UNITED STATES PATENT AND TRADEMARK OFFICE

APPLICATION NO.	FILING DATE	FIRST NAMED INVENTOR	ATTORNEY DOCKET NO.	CONFIRMATION NO.
09/998,944	10/31/2001	Sidney M. Bennett	KVC-051.01	5937

Office Action Summary

Office Action

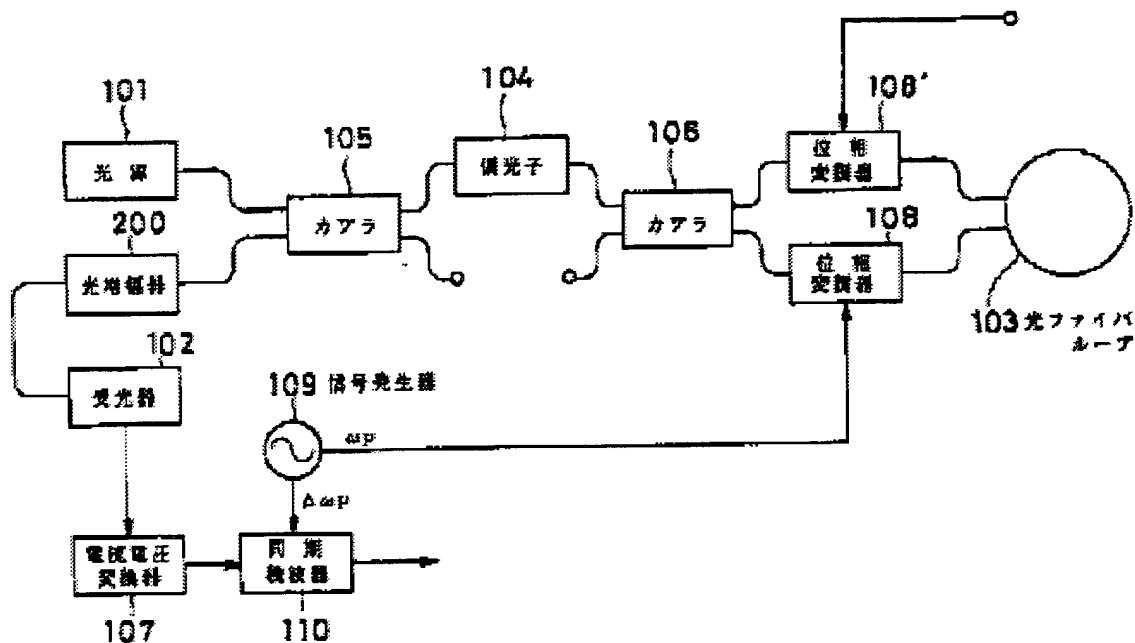
Claims 1 and 19 are rejected under 35 U.S.C. § 102(b) as being clearly anticipated by Sakuma et al(JP407294264A).

Sakuma et al teach an all fiber Sagnac sensor gyroscope comprising a source(101), first coupler(105), polarizer(104), second coupler(106), modulators(108,108'), fiber coil(103), and detector(102). One modulator(108) is driven by a bias source(109) to bias the sensor while the modulator(108') can be used to provide a closed loop phase nulling configuration. This is all notoriously well known prior art. Sakuma however also places an optical amplifier(200) between the first coupler(105) and the detector(102).

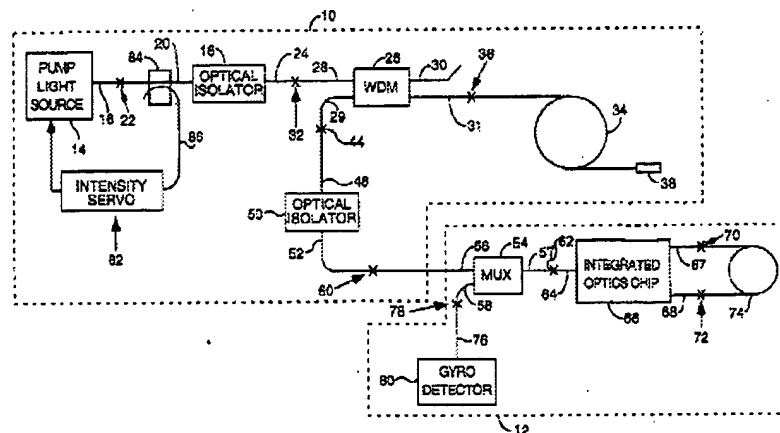
Rozelle et al teach a Sagnac sensor comprising a fiber pumped source(10), wavelength division multiplexer(54), integrated optics chip(66), fiber coil(74), and detector(80). optical isolators(18,50) are used to isolate the pump source from the fiber laser(34) while the isolator(50) isolates the fiber laser from the sensor output.

It would have been obvious to one of ordinary skill in the art at the time the invention was made to isolate various optical sources which would include and optical amplifiers from the output of previous optical elements. In the case of Sakuma it would have been obvious to position an isolator between the optical amplifier and the first coupler in order to isolate the sensor from the output from the optical amplifier which would then be seen as noise.

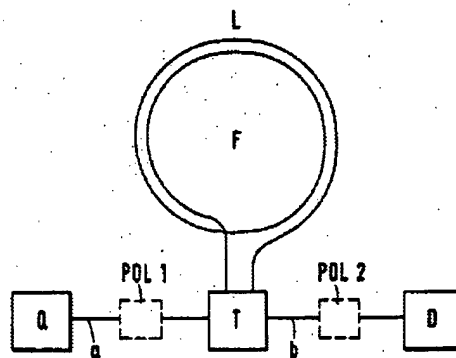
This reference teaches placing a polarizer(POL2) at the detector(D) in order to pass only the desired polarization and thus further eliminating polarization crosstalk from the fiber coil and increasing accuracy.

It would have been obvious to one of ordinary skill in the art at the time the invention was made to modify the Sakuma sensor by placing a polarizer at the detector in order to pass only the desired polarization and thus further eliminating
